# *Town of Brookline*
## *Massachusetts*

To: Brookline Board of Appeals

Subject: Construct a single-story addition at the rear totaling 66.5 square feet

Location: **79 Williston Road**

## FLOOR PLAN AT KITCHEN & MUDRM.

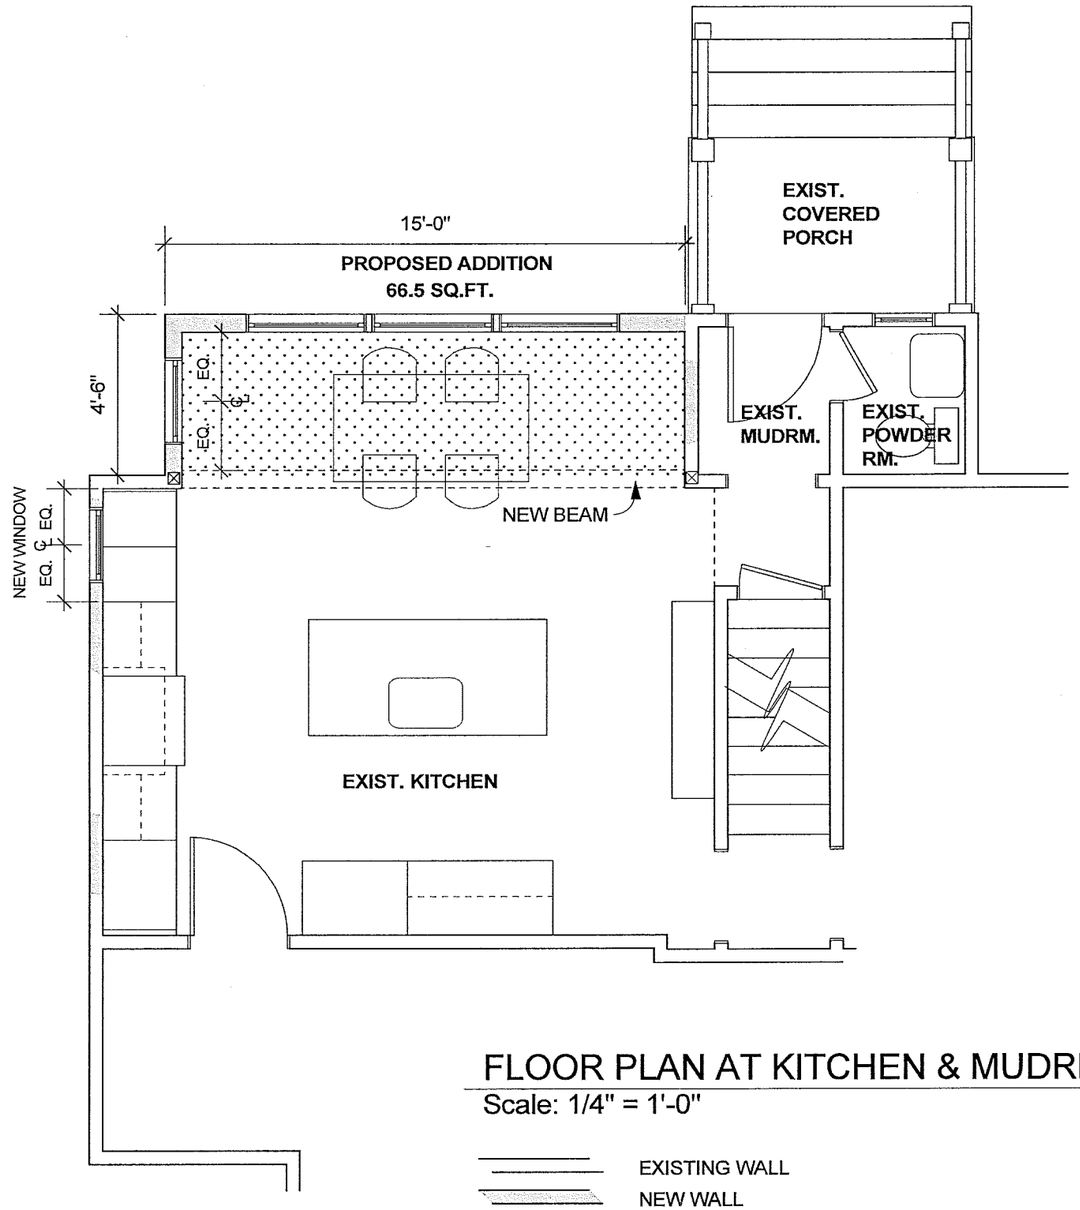
*Preservation of Trees and Landscape:* The modest rear addition requires no tree removal however the proposed expansion of the building footprint does necessitate the elimination of a small landscaped area that includes mulch and shrub plantings.

*Circulation:* There would be no change in the existing parking configuration based on the location of this rear addition. Additionally, the functionality of the rear yard is not adversely affected by the modest expansion of the structural footprint into the rear yard.

1. **Prior to the issuance of a building permit, the Applicant shall submit a final site plan, floor plans, and elevations, subject to review and approval by the Assistant Director for Regulatory Planning.**

| HEIDI HELF, ARCHITECT | RUSSO RESIDENCE | Print Date | Drawing | Sheet # |
|---|---|---|---|---|
| BROOKLINE, MA<br>617-232-5110<br>hjhelf@gmail.com | 79 WILLISTON ROAD<br>BROOKLINE, MA | APRIL 11, 2016 | PROPOSED<br>EXTERIOR ELEVATIONS | 2 |

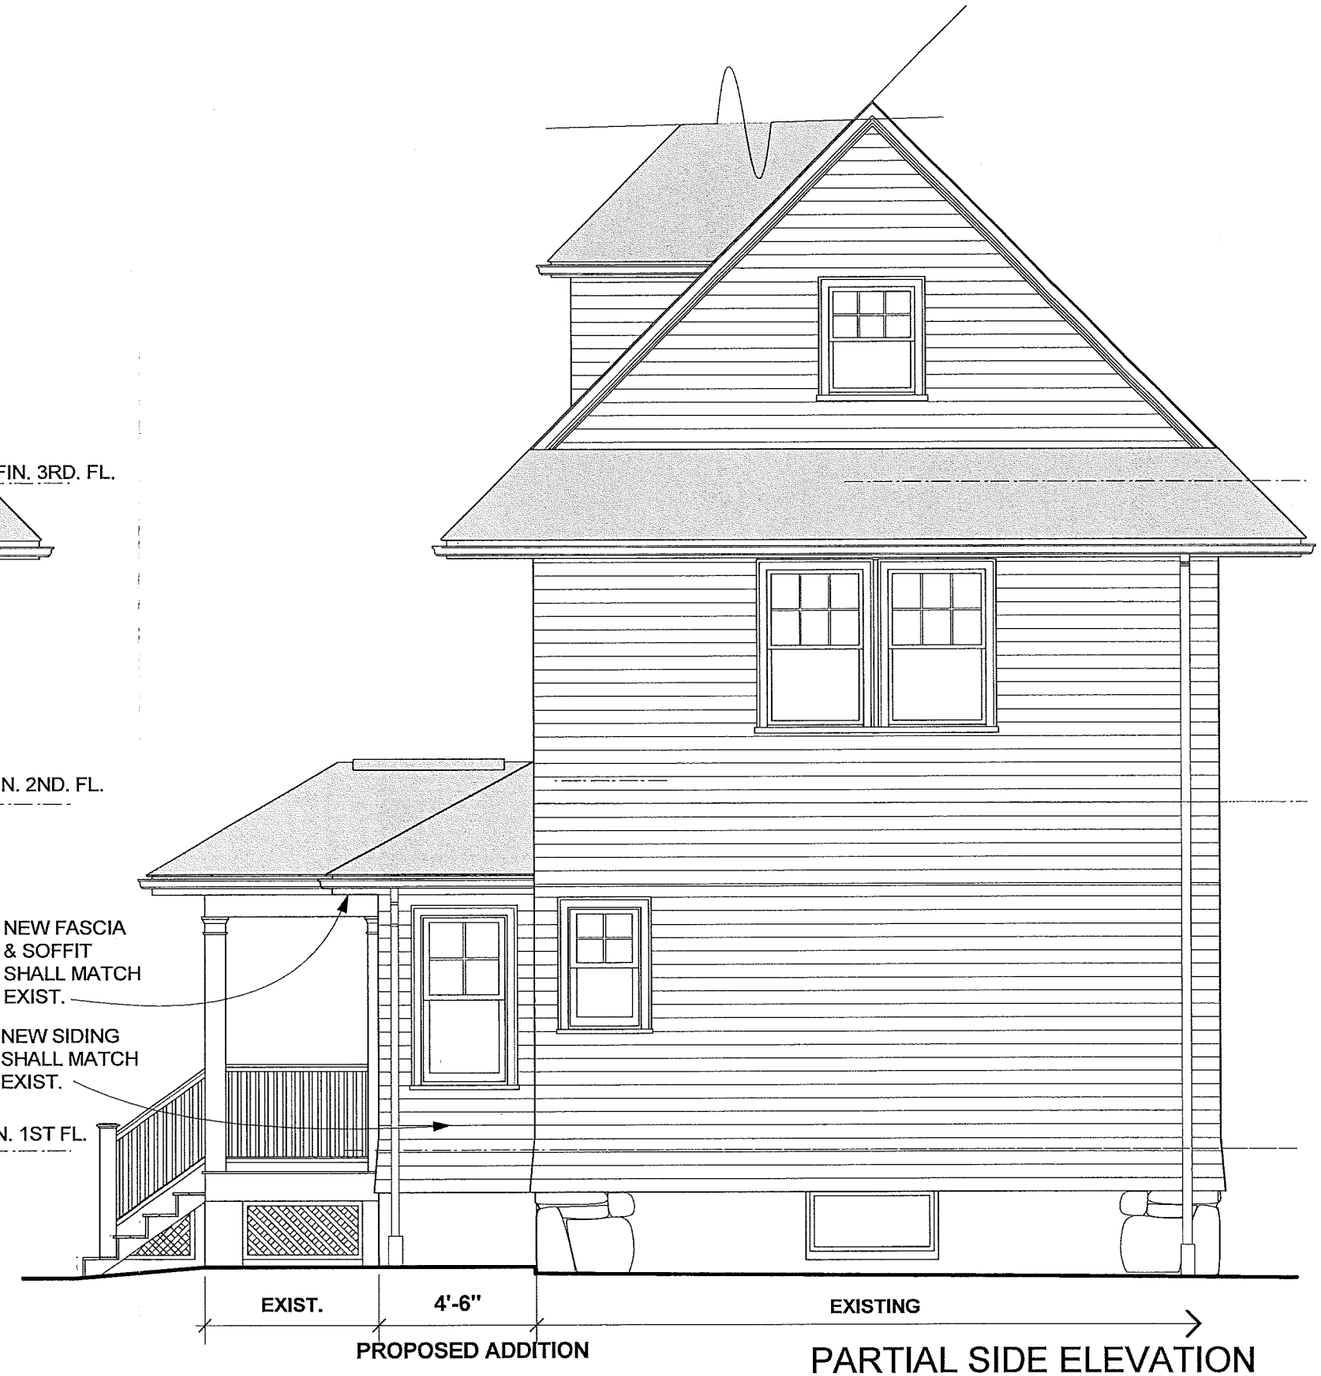
The Planning Board has no objection to the relief as requested. The proposed rear addition is modest in scale and is intended to improve the interior functionality of the home. The location and scale of the addition are not anticipated to result in adverse impact on abutting properties or residents. The exterior addition is well designed and incorporates building materials, roof pitches, fenestration that mimic existing design features of the structure.
